This page lists the know errors on the gm5x5x5 PCBs. There are no known issues with the bulk order run (white pcbs), the following information is valid **only** for the prototype run (green pcbs).

Bulk Order #1 (white pcb, rev 1.0)

#1 MIDI IO pins

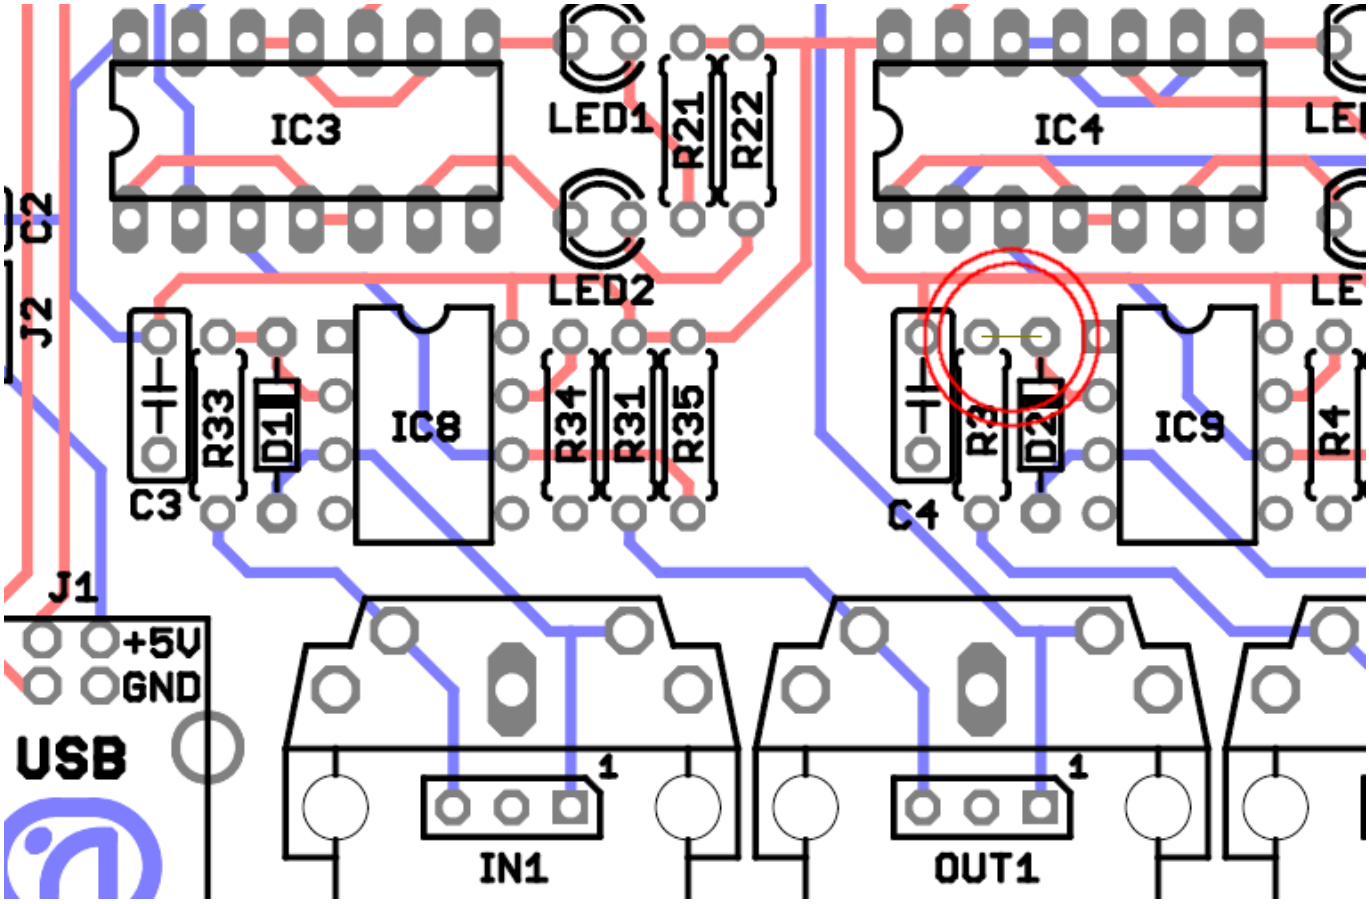
Problem: The MIDI IO pins of the midi sockets (Pin 4 + 5) are switched.

Solution: Either (1) use the pin-headers if you use sockets that are not mounted on the pcb or (2) break the traces to pins 4 + 5 of the sockets and solder wires to them or (3) solder the midi sockets on the other side of the pcb.
